Amendment to the Drawings:

Transmittal of the replacement sheet for formal drawings of FIG. 1.

Application No.: 10/719,504

FIG. 1

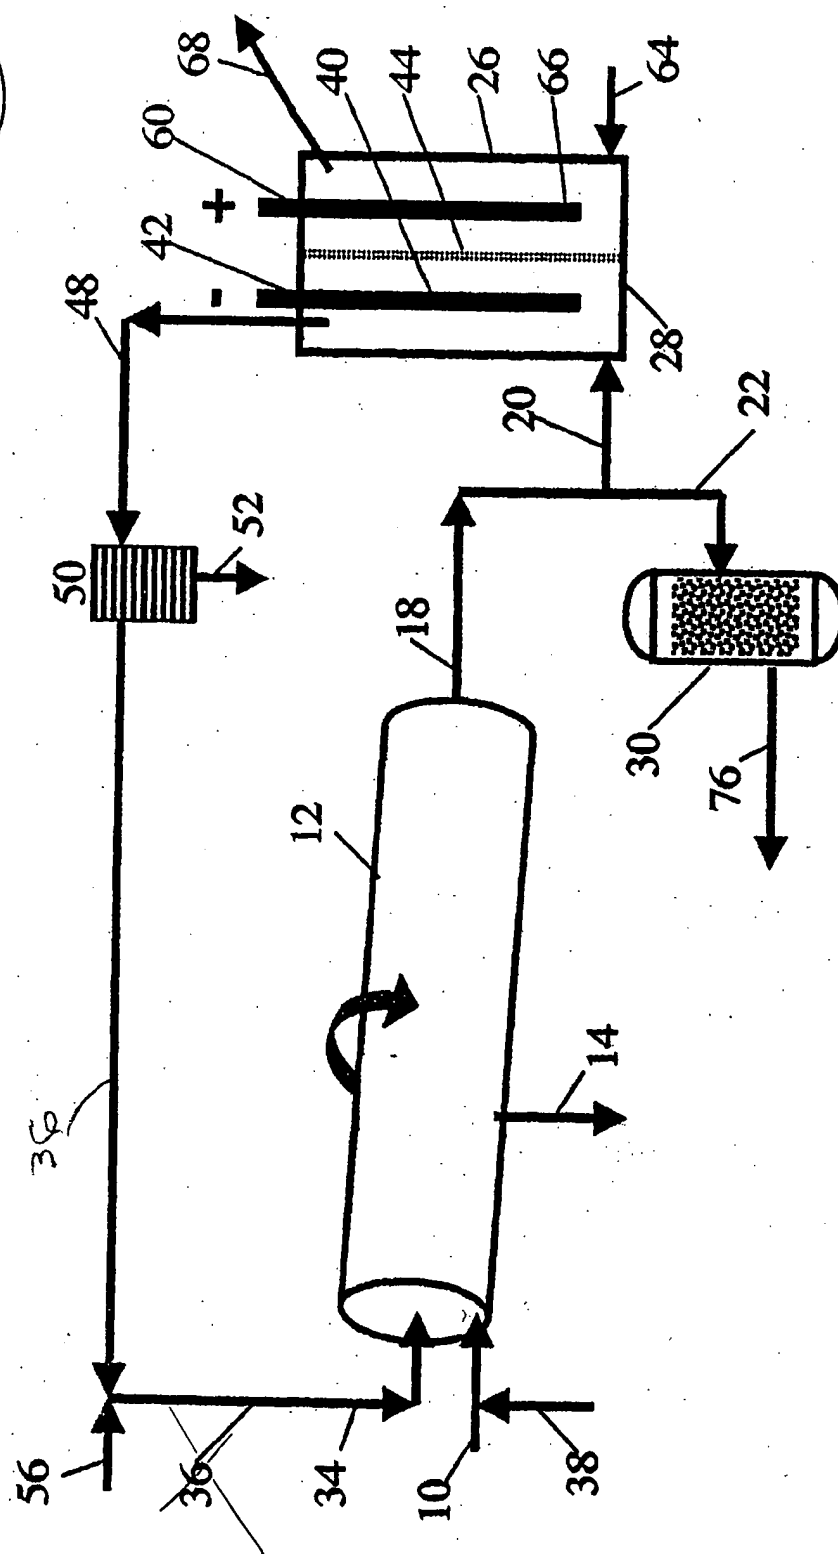
The attached sheet of formal drawing of FIG. 1 replaces the previous formal drawing of FIG. 1 submitted with the parent application filed November 21, 2003. The attached sheet of the formal drawing of FIG. 1 corrects the misalignment of lead line 36 so that, instead of leading to line 34, line 36 now leads to the line running between line 56 and condenser 50. This change does not introduce new matter.

FIG. 1 has been amended to correct the misalignment of a lead line and a new formal drawing of FIG. 1 has been attached.
